FARR WEST CITY
COUNCIL AMENDED AGENDA

RE: BEN LOMOND BUSINESS PARK
Subdivision Plat and Plans Review

LOCATED IN THE SOUTHEAST QUARTER OF SECTION 2, TOWNSHIP 6 NORTH, RANGE 2 WEST, SALT LAKE BASE AND MERIDIAN

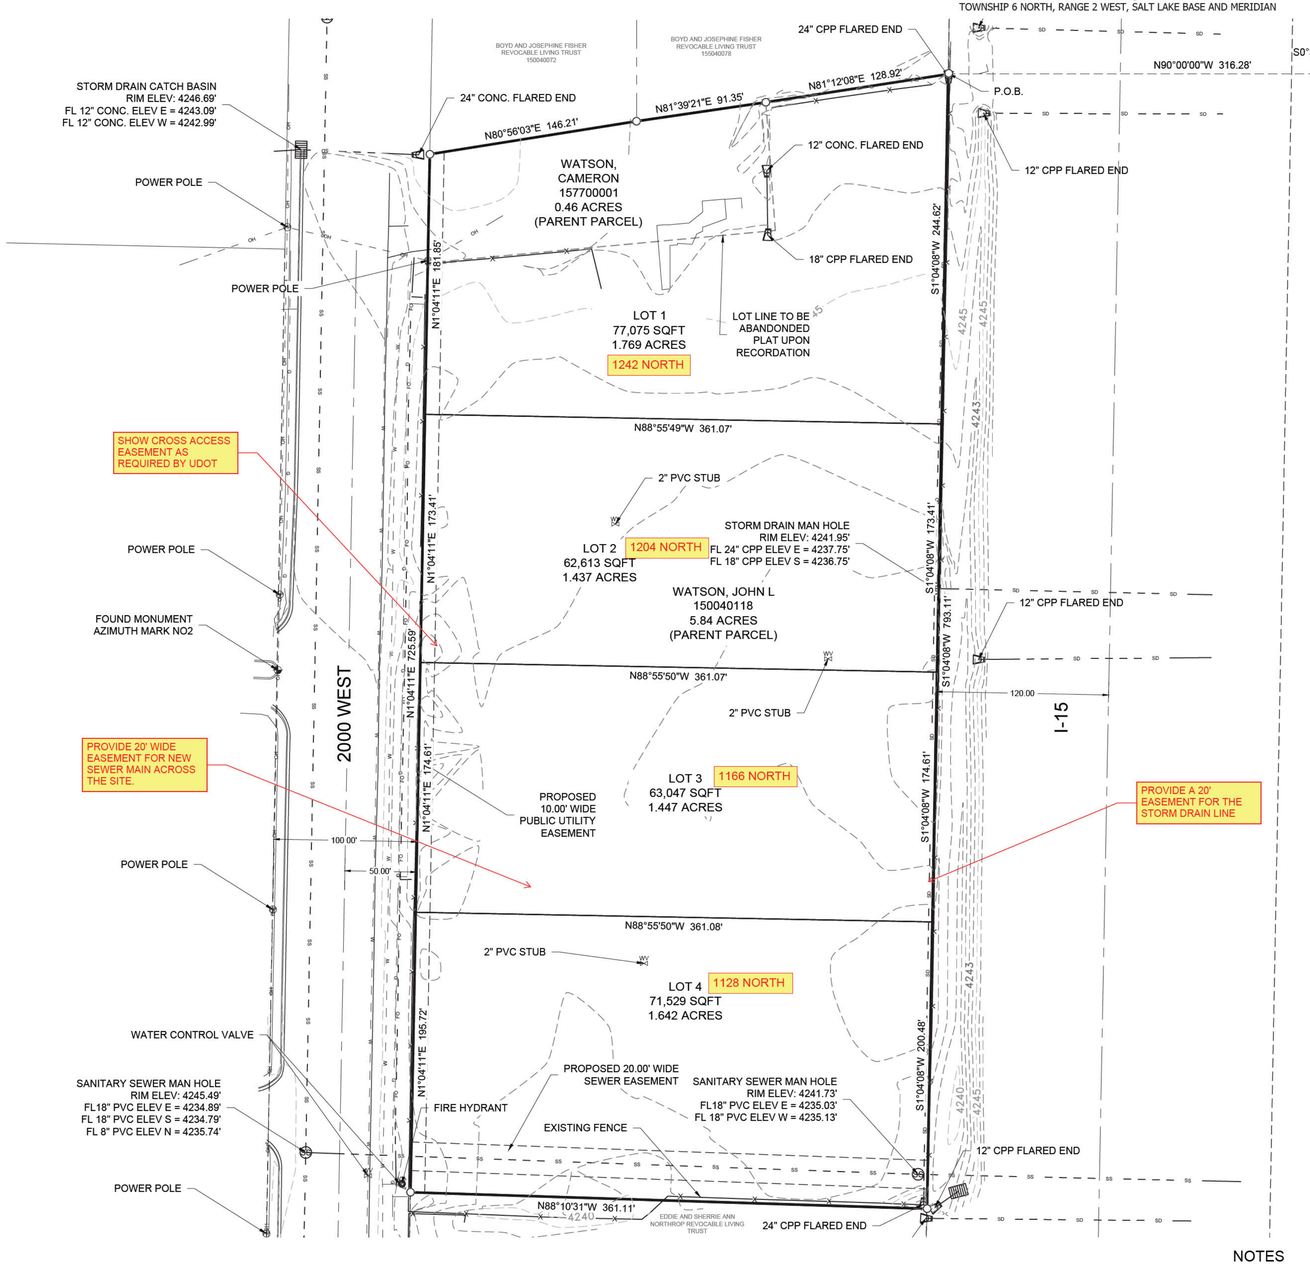
1. Obtain UDOT approval for access to 2000 West. UDOT will likely only allow one access into the site; a cross access easement between the lots will be required and will need to be shown on the plat.
2. Add addresses to the lots as provided by our office.
3. Provide a sewer easement on behalf of the City for the new sewer main that will be installed on the site. The individual laterals will be private and will not need any easements, but the main line will need to be a public line and an easement over the pipe is necessary.
4. Provide a storm drain easement on behalf of the City for the existing storm drain running along the east side of the property.
5. See the red-line comments on the plat and make sure all comments are addressed.
